**DEVIATION REVIEW
 AND DECISION FORM**

Deviation No. 2

Subdivision or Project Name: Rollin' Ridge Estates

Cherry Crossing Drive Intersection Spacing

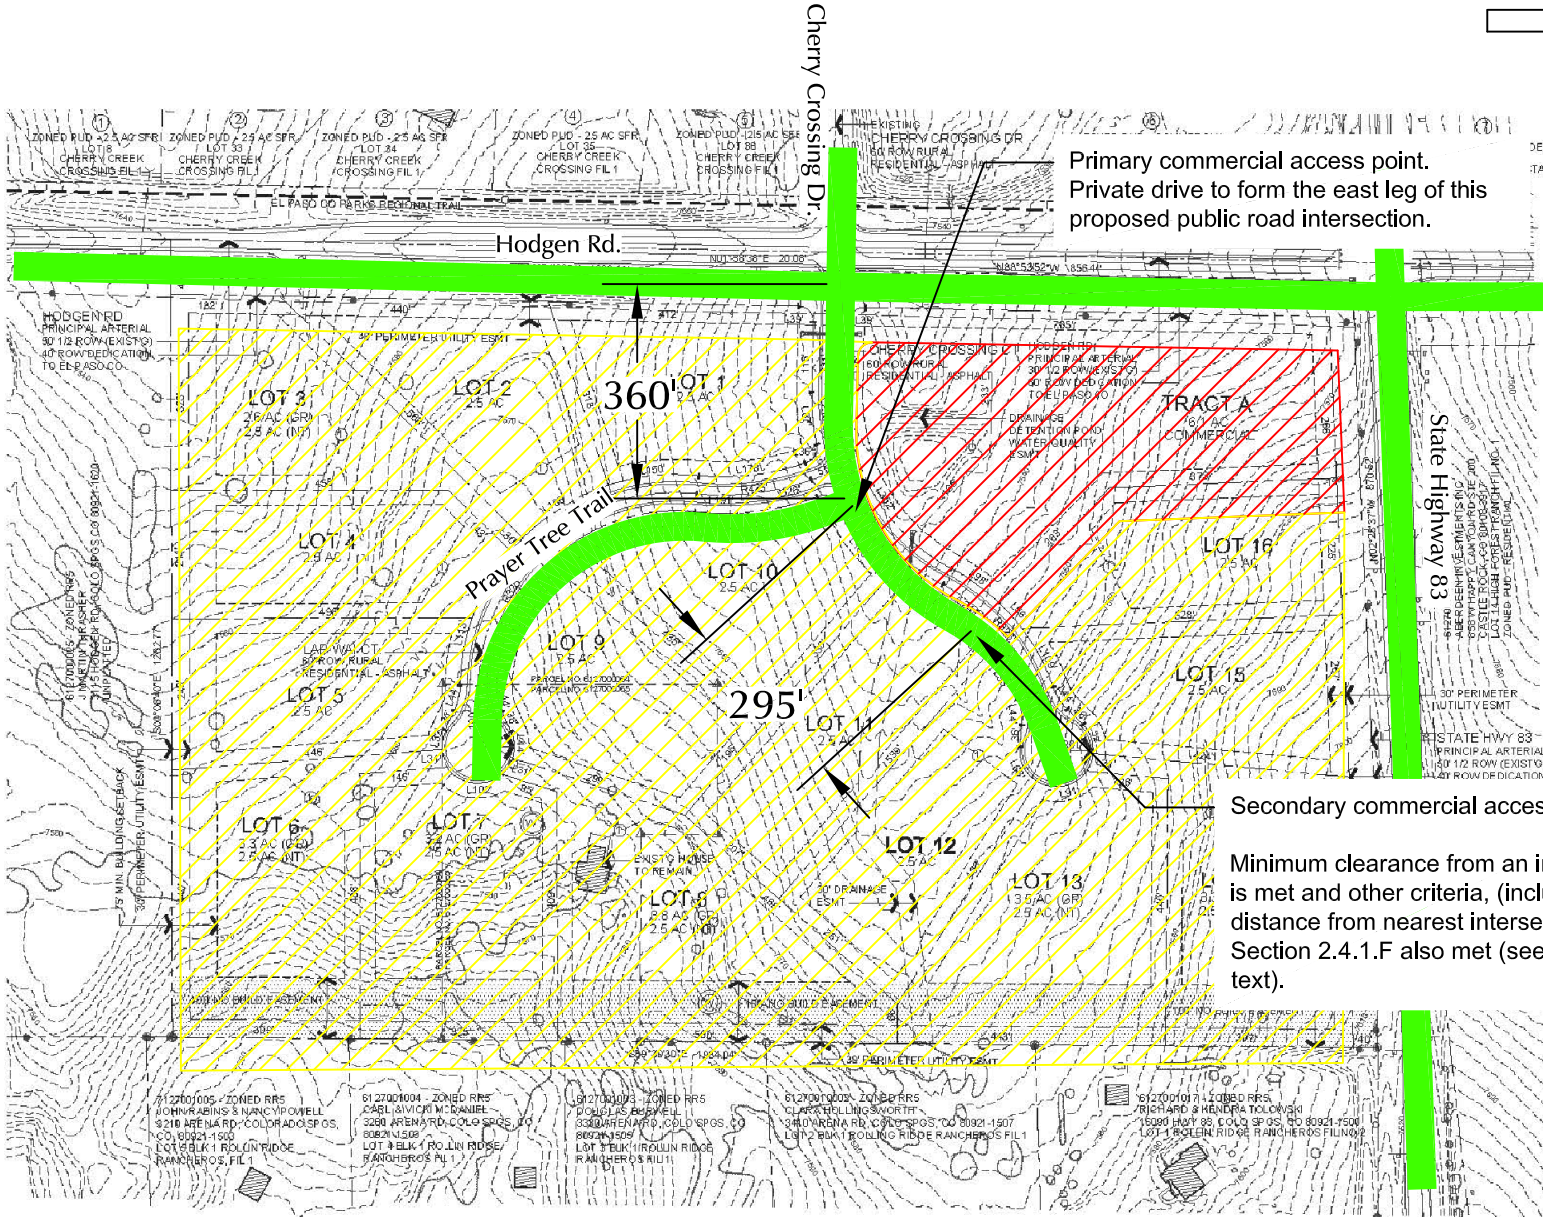
Proposed Nature and Extent of Deviation: The ECM-prescribed intersection spacing along a Rural Minor Arterial is one-quarter mile. This deviation request is to allow a spacing of 360 feet instead of the ECM-prescribed one-quarter mile spacing. This spacing is for Cherry Crossing Drive between Hodgen Road and the first public road (Prayer Tree Trail) intersection to the south of Hodgen (Note: the east leg of this intersection will be the proposed north commercial access driveway-a private leg of a public street intersection). Please refer to the attached exhibit.

Comparison of Proposed Deviation to ECM Standard: The proposed centerline intersection spacing along Cherry Crossing Drive between Hodgen Road and this first public street intersection is 360 feet. This spacing is 960 feet short of the ECM standard intersection spacing of one-quarter mile.

The 2040 queuing analysis contained in the TIS indicates that the proposed intersection spacing will be sufficient to accommodate vehicle turning movements, projected vehicle queues, turn lanes of sufficient length and associated tapers (please refer to separate deviation for turn lane lengths), and sufficient intersection and stopping sight distance. Please refer to the attached exhibit showing the intersection spacing for this section of Cherry Crossing Drive.
